**DOCUMENT 00 90 00
ADDENDUM**

ADDENDUM NO. [1] Date: February 16, 2021

**RE: WESTERN TECHNICAL COLLEGE
 SPARTA PUBLIC SAFETY EXPANSION
 11177 COUNTY HWY A
 SPARTA, WISCONSIN 54656
 HSR PROJECT NO. 20028**

FROM: HSR Associates, Inc
 100 Milwaukee Street
 La Crosse, WI 54603
 (608) 784-1830

1 FIRST FLOOR LOW VOLTAGE PLAN - AREA A
SCALE: 1/8" = 1'-0"
20-07-E-LV01

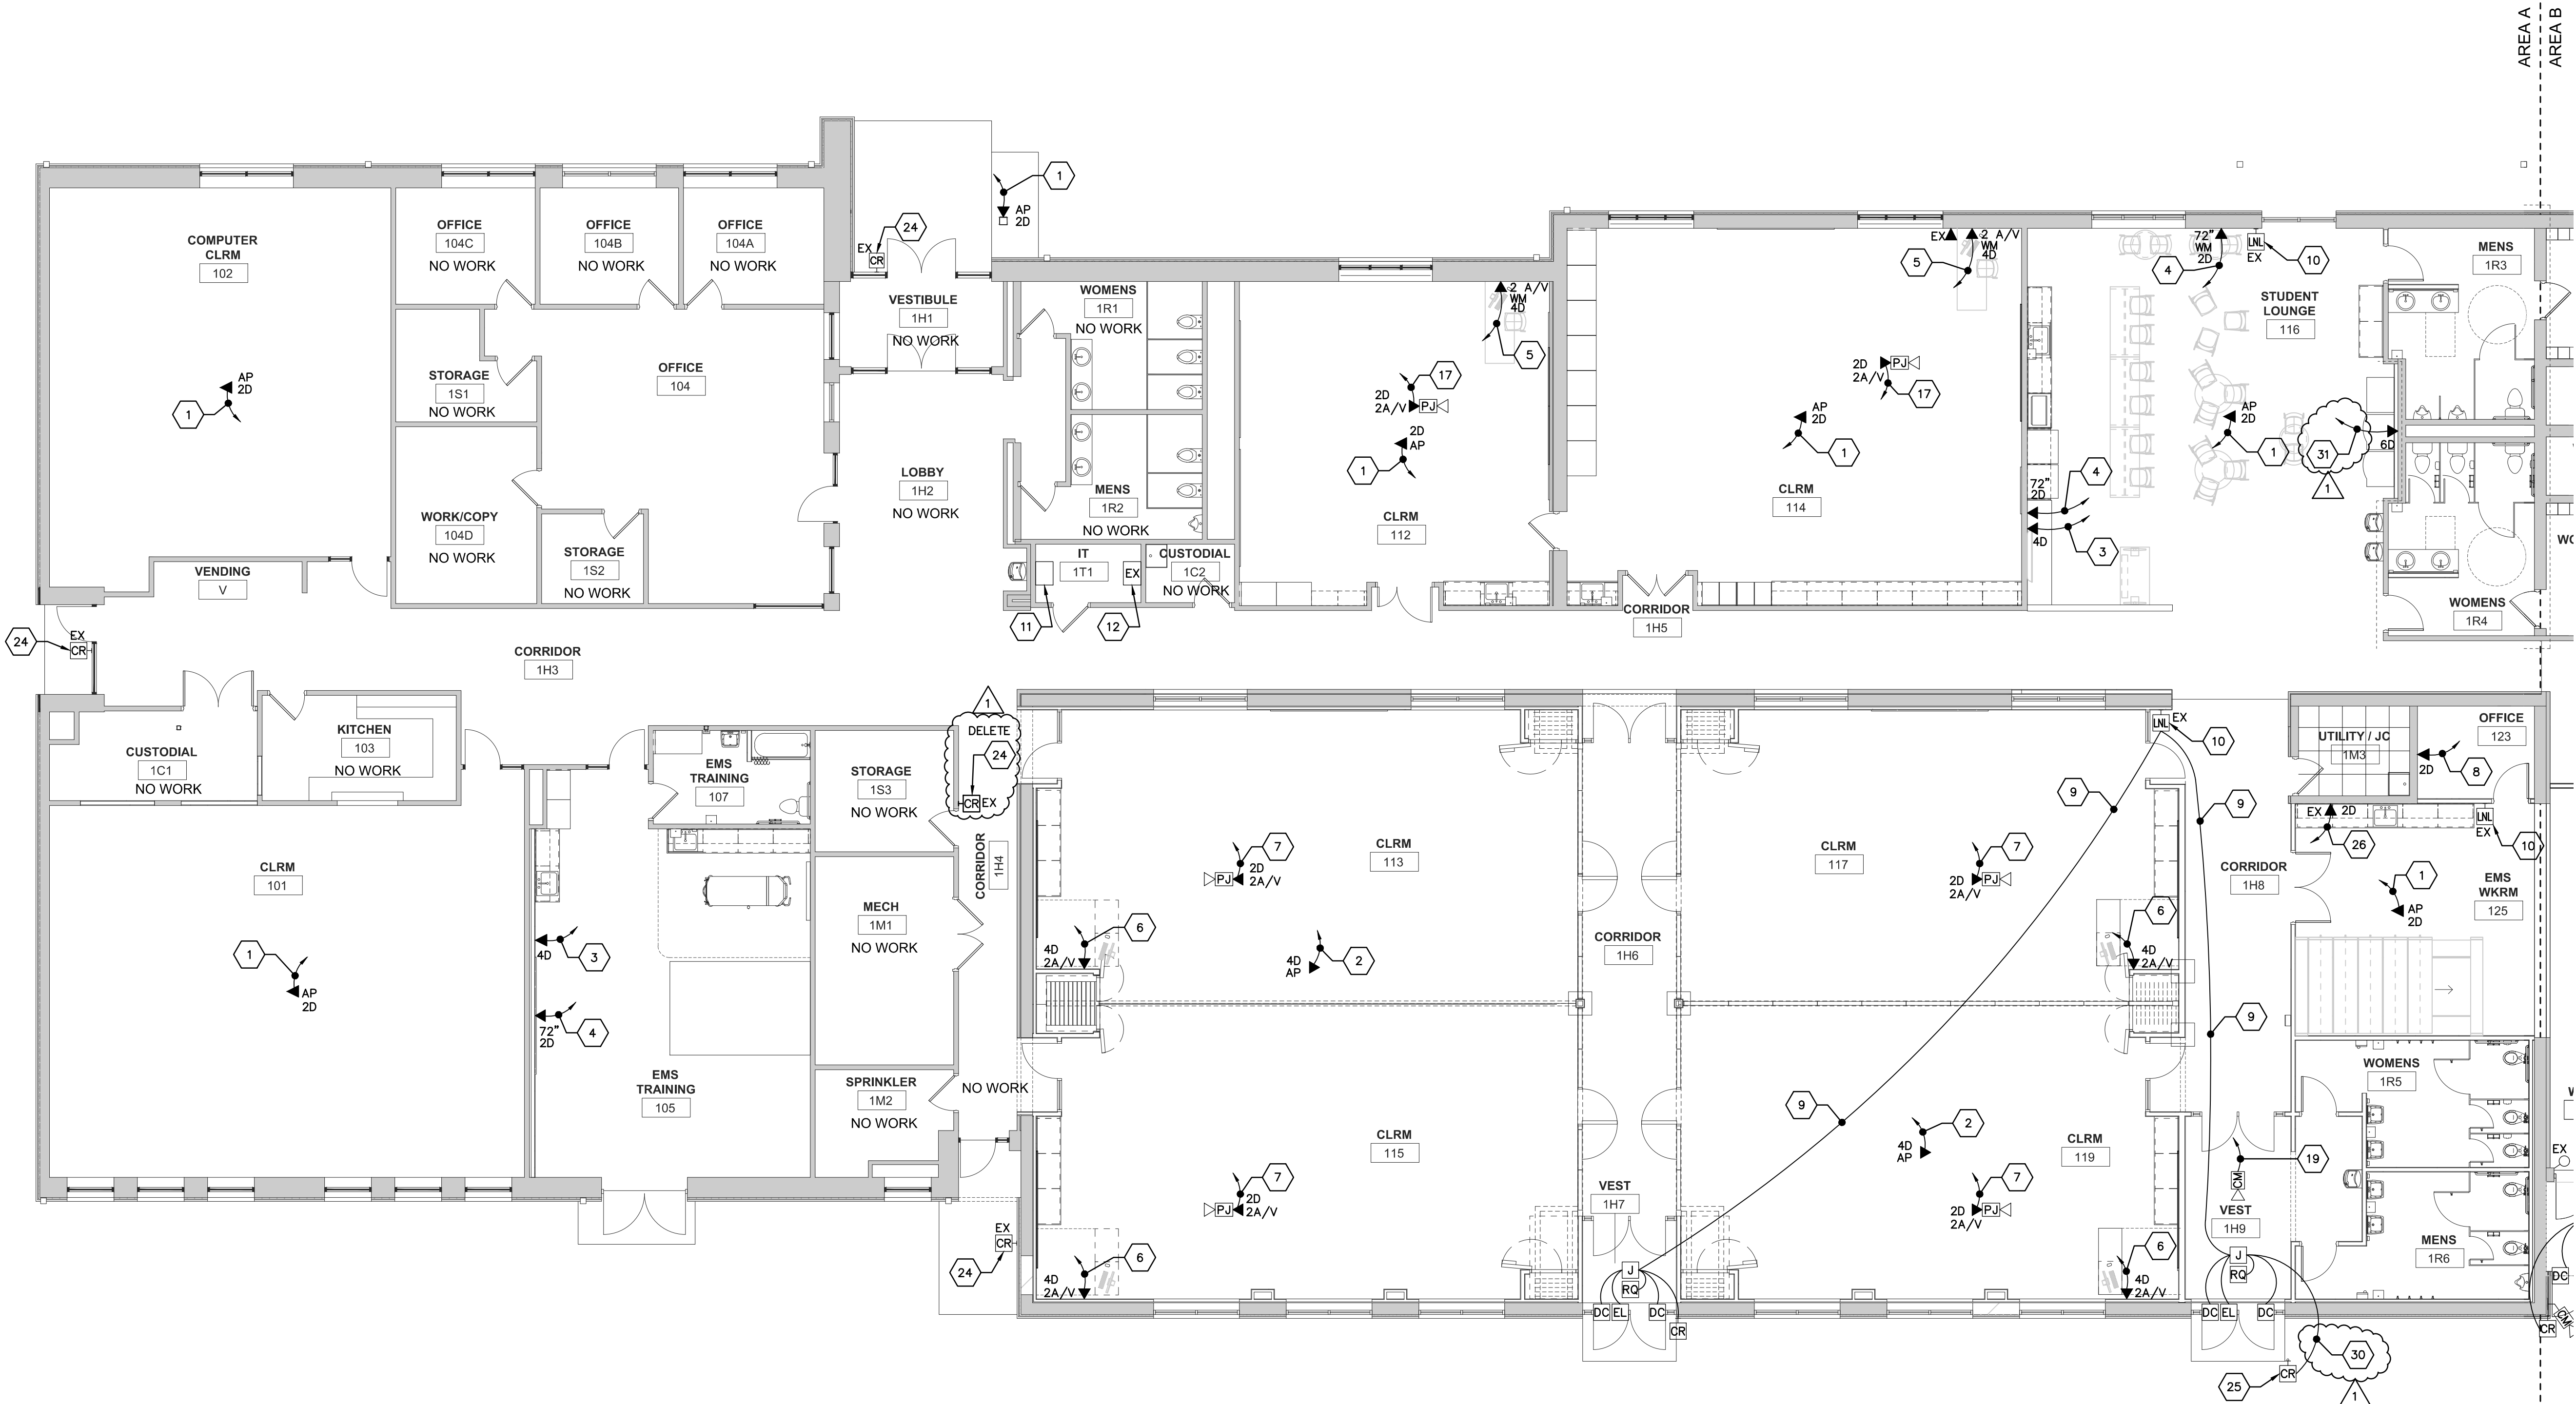
30. Sheet E301 FIRST FLOOR LOW VOLTAGE PLAN – AREA A 30 x 42 attached hereto
 - a. Revisions clouded on Drawing.
 - b. Existing Electronic Door Card Reader located at entrance door into Storage Room #1S3 has been deleted and will be erased from this plan. Refer to clouded change dated 2-15-2021.

- c. Refer to Electronic Door Card Reader located at exterior pedestal at Vestibule 1H9. Keyed Note #30 has been added addressing underground exterior communication cable to be installed. Refer to clouded change dated 2-15-2021.

- d. Refer to Student Lounge #116, keyed note #31 has been added to the 6D Data Jack located on East Wall. Refer to clouded change dated 2-15-2021.
31. Sheet E302 FIRST FLOOR LOW VOLTAGE PLAN – AREA B 30 x 42 attached hereto

1 FIRST FLOOR LOW VOLTAGE PLAN - AREA B
E302 SCALE: 1/8" = 1'-0" 20-07-E-LV01

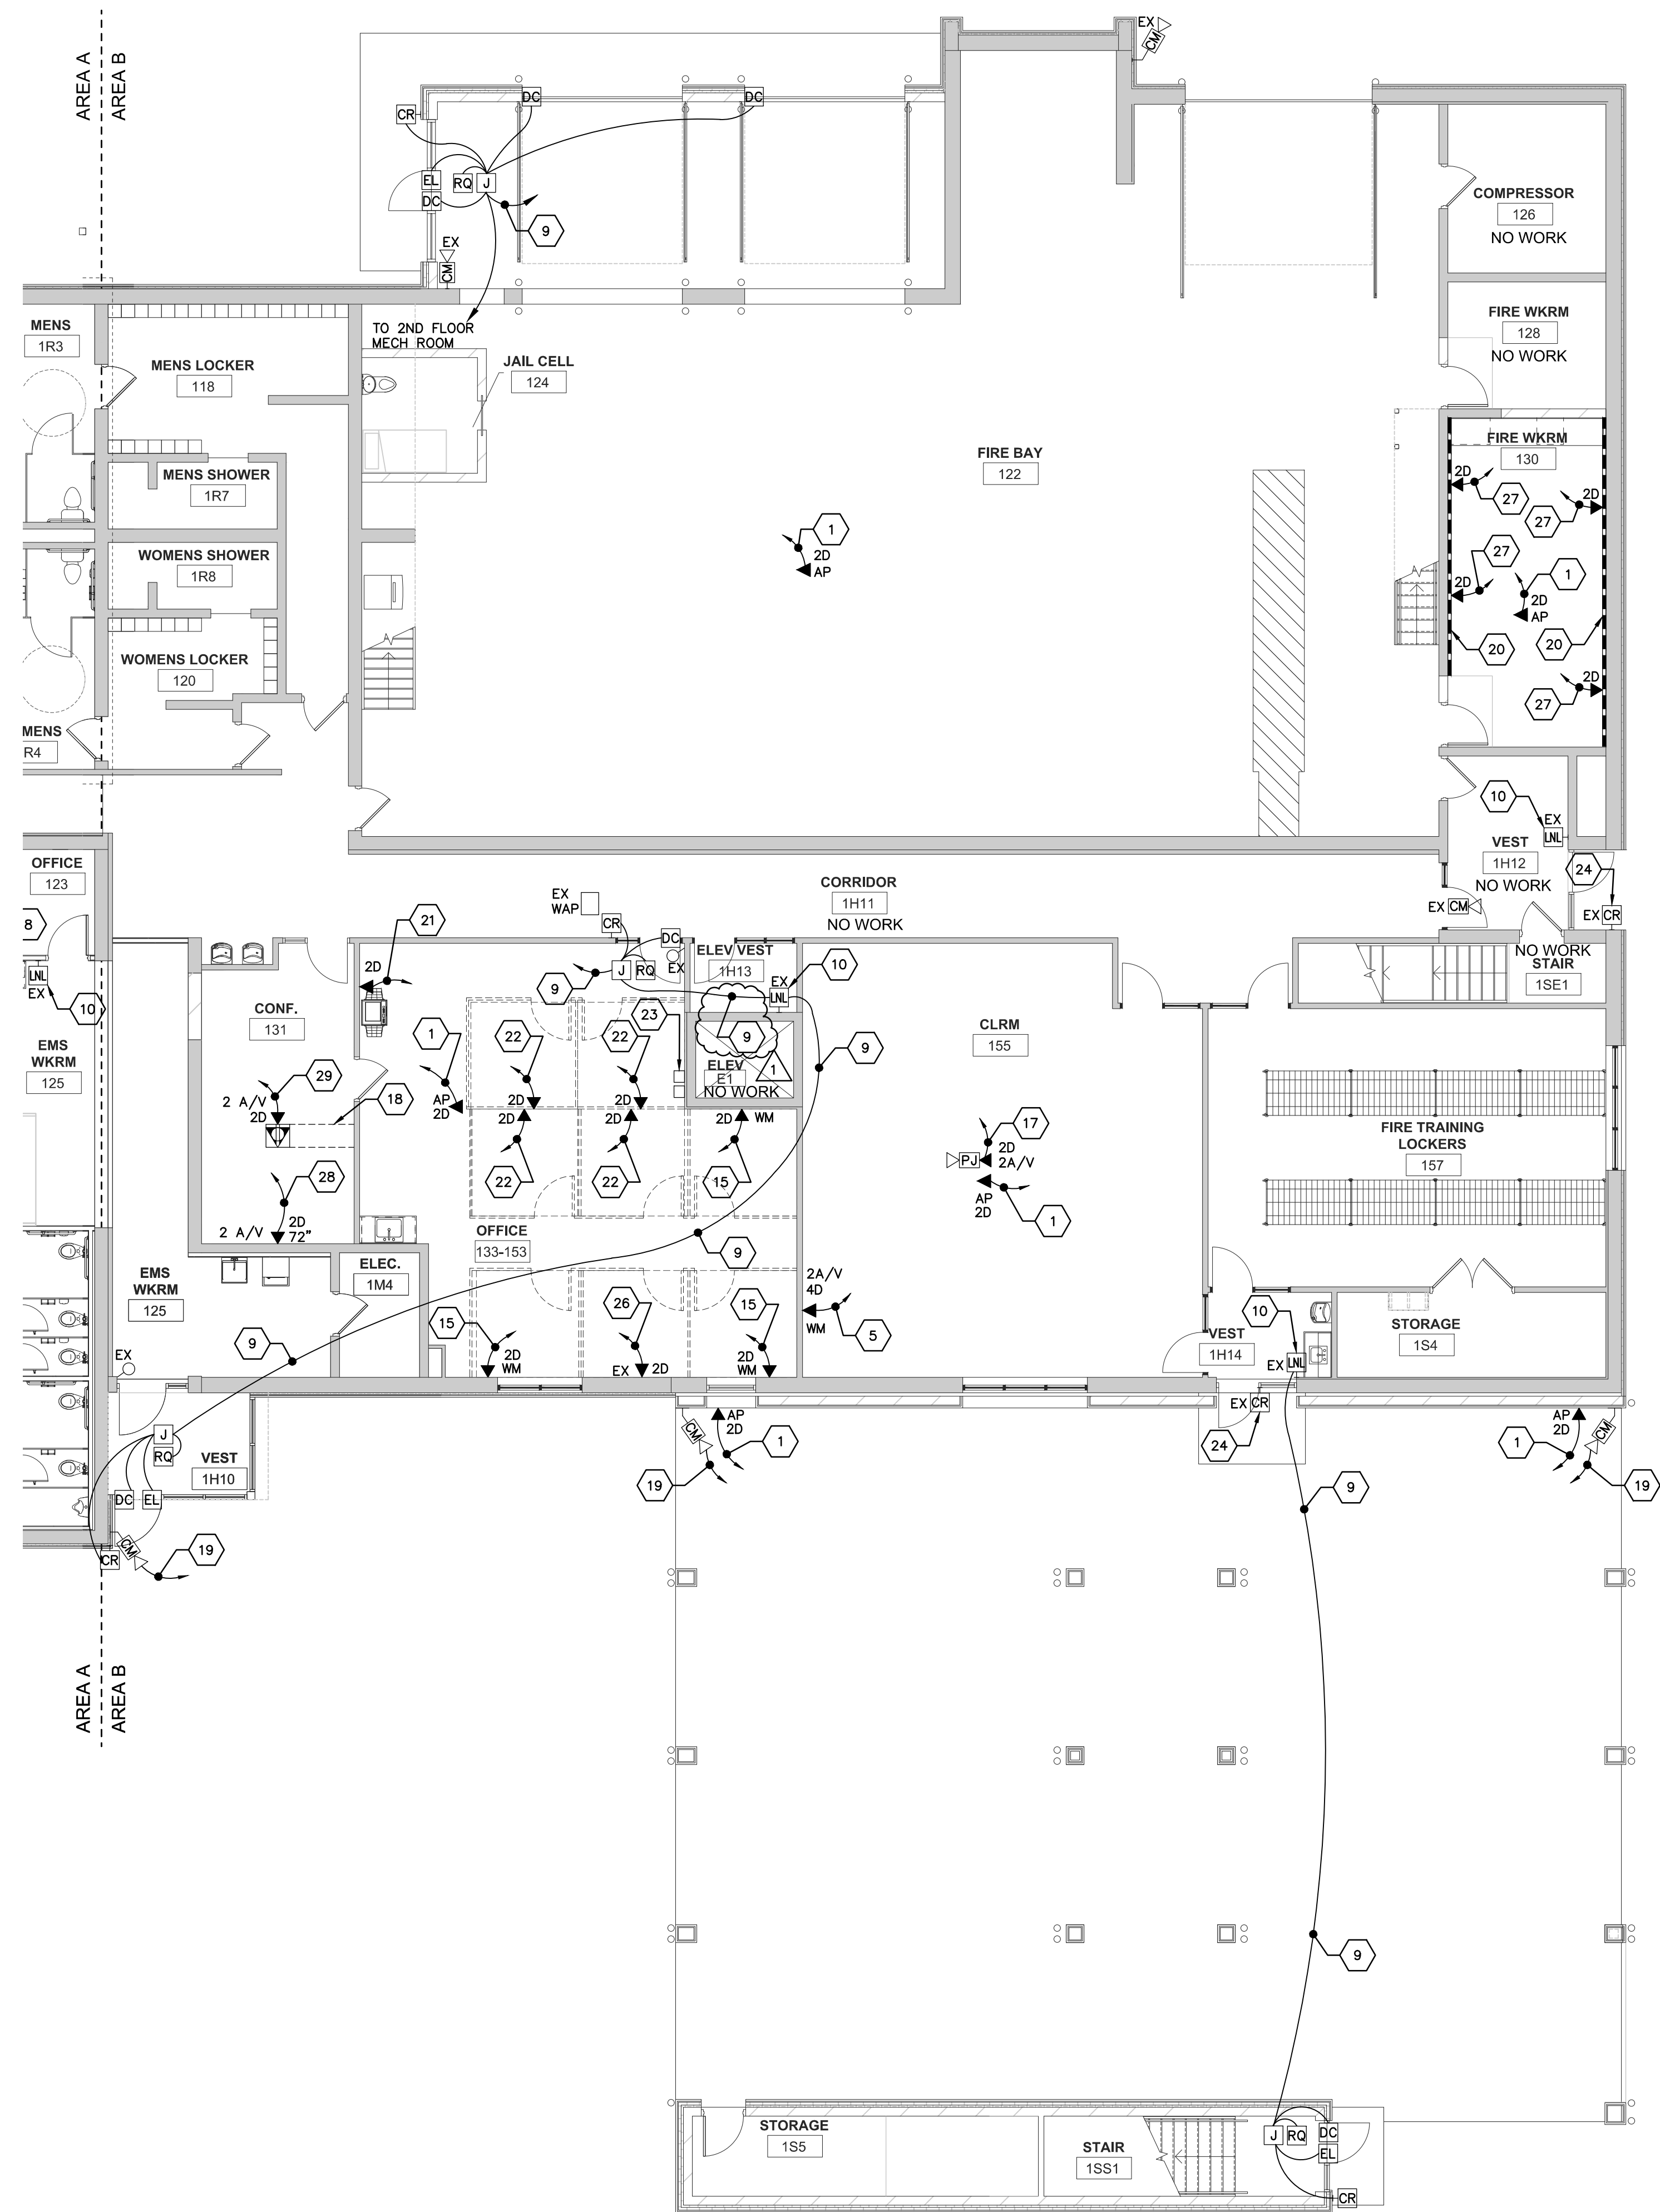
- a. Revisions clouded on Drawing.
 - b. In Elevator Vestibule 1H13, keyed note #9 has been added. Refer to clouded change dated 2-15-2021.
32. Sheet E303 SECOND FLOOR LOW VOLTAGE PLAN – AREA B 30 x 42 attached hereto

E303

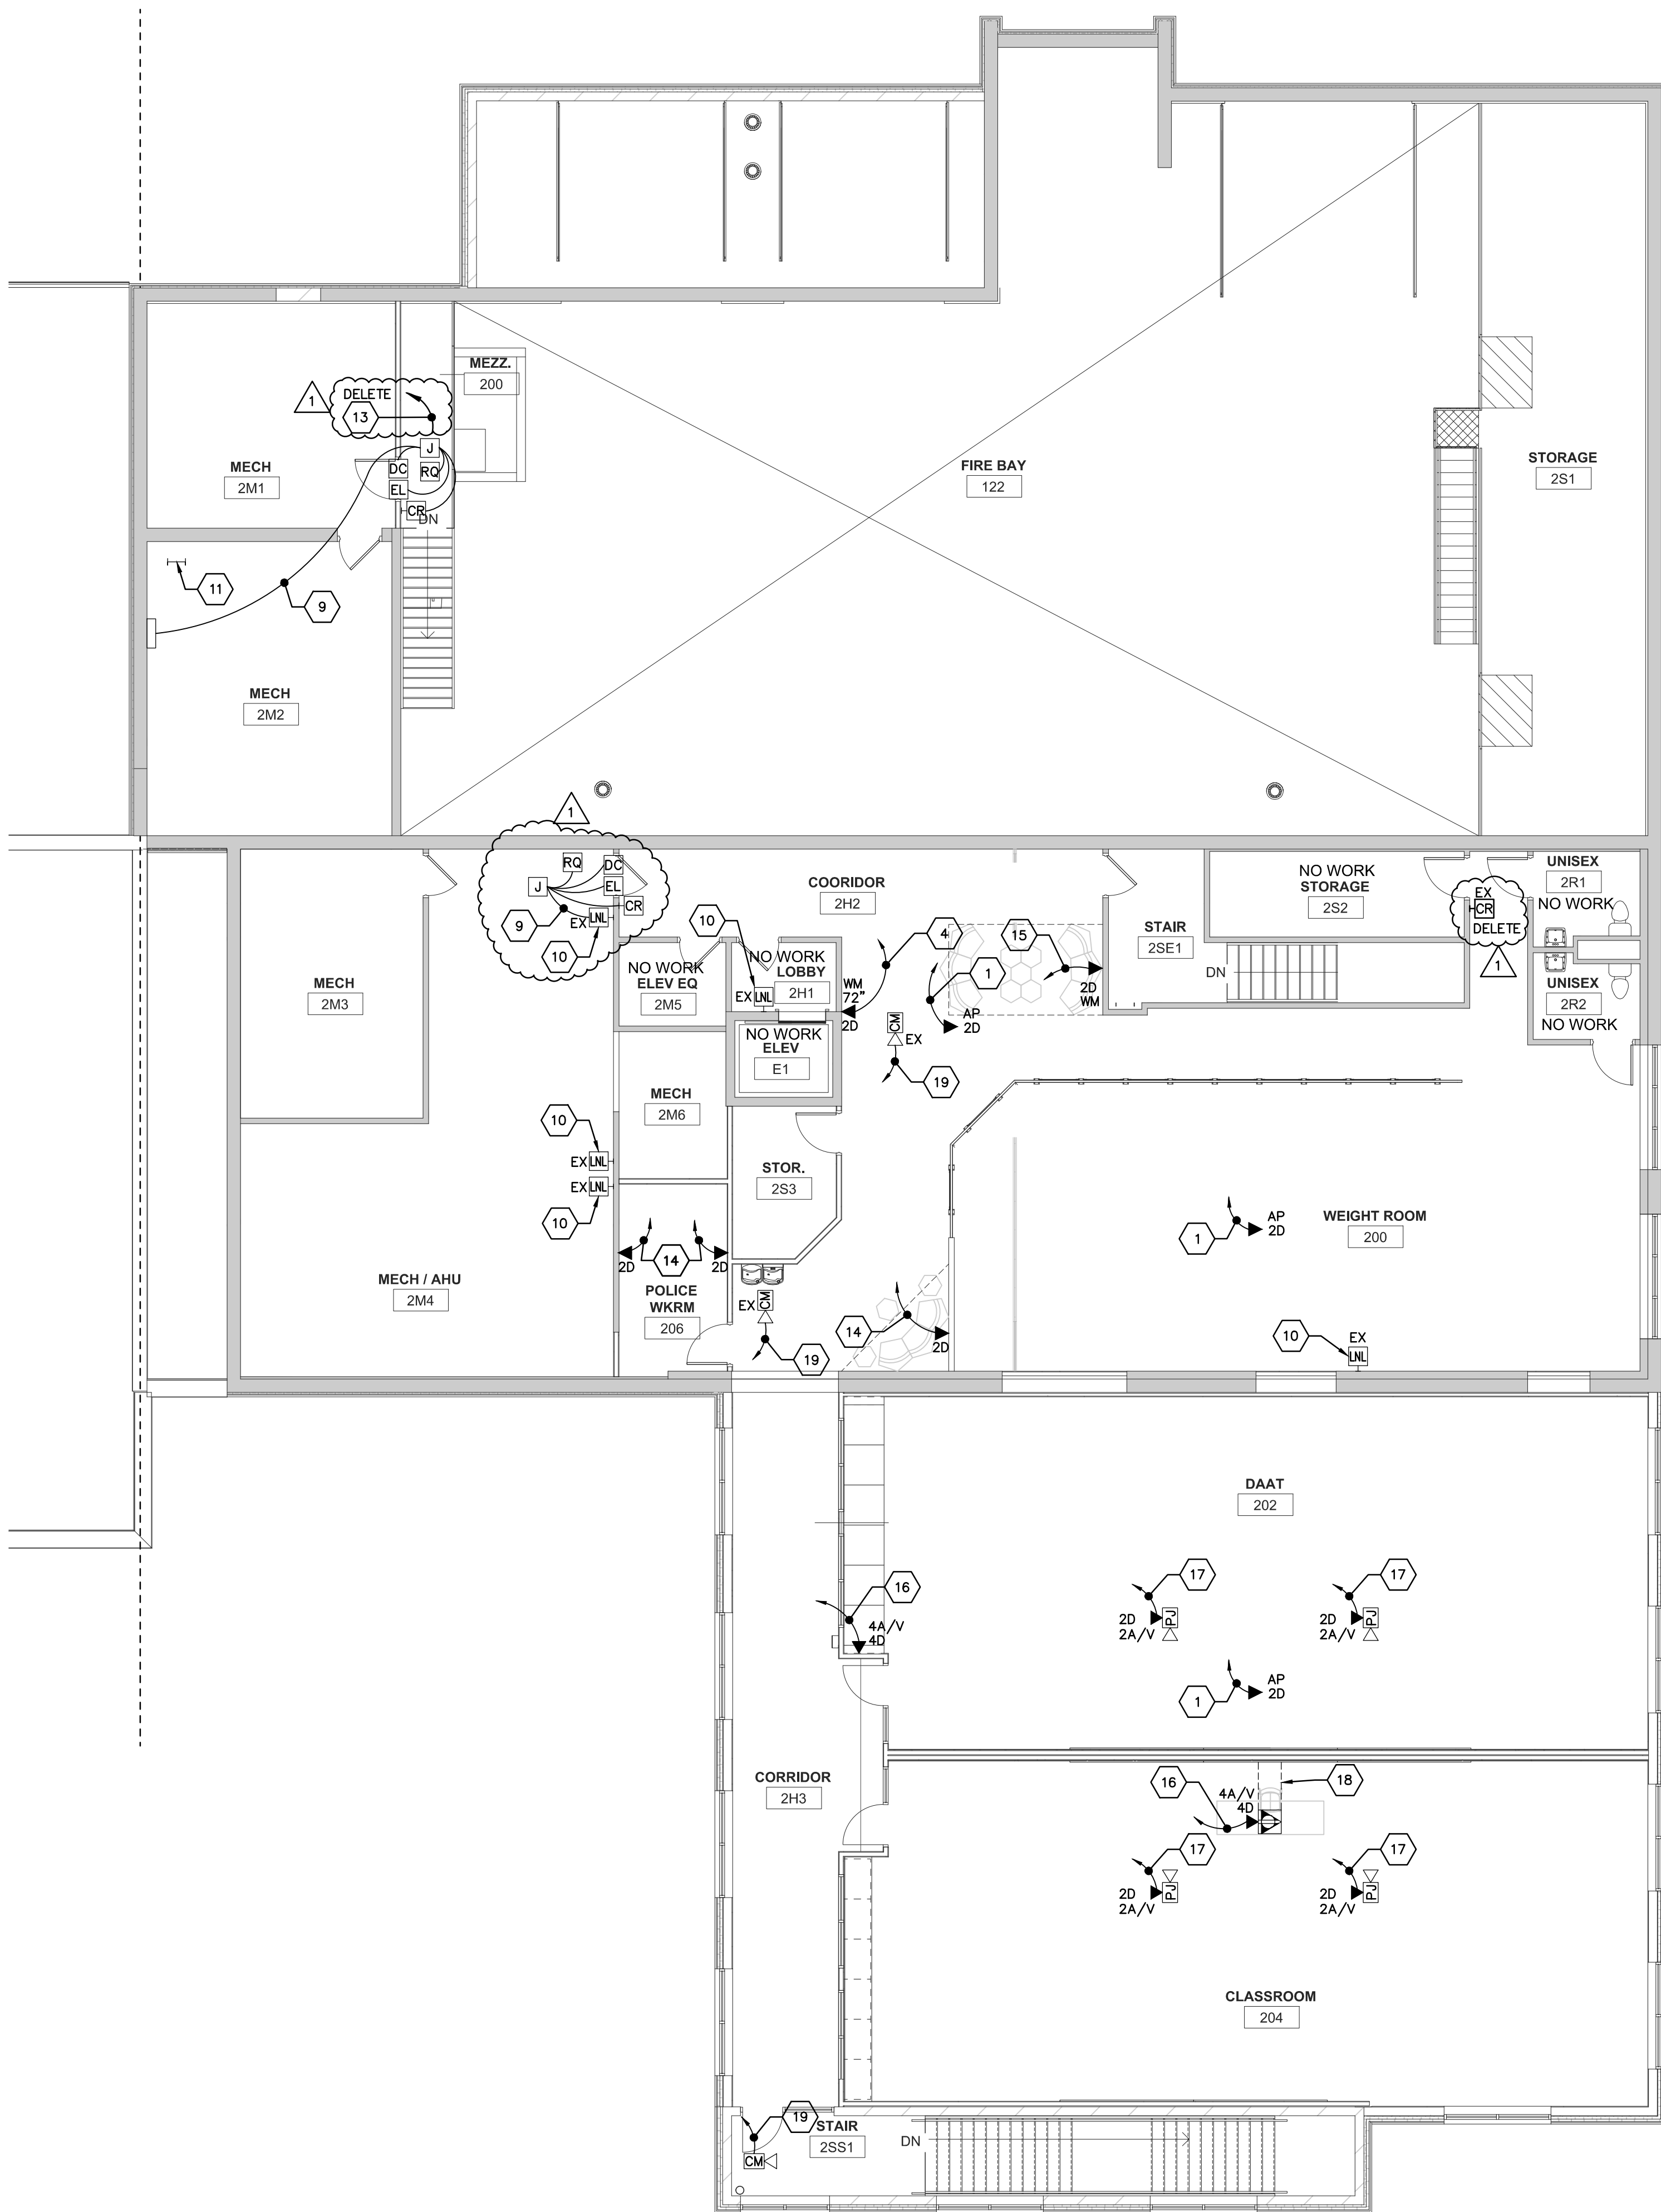
- a. Revisions clouded on Drawing.
 - b. In Corridor #2H2, add One (1) Electronic Door Access Control Card Reader at the door entering Mechanical Room #2M4. Refer to clouded changes dated 2-15-2021.

- c. Existing Electronic Door Card Reader located at entrance door into Storage Room #2S2 has been deleted and will be erased from this plan. Refer to clouded change dated 2-15-2021.

- d. In Mechanical Room #2M1, delete keyed note #13. Refer to clouded change dated 2-15-2021.
33. Sheet E501 SCHEDULES 30 x 42 attached hereto
- a. Revisions clouded on Drawing.
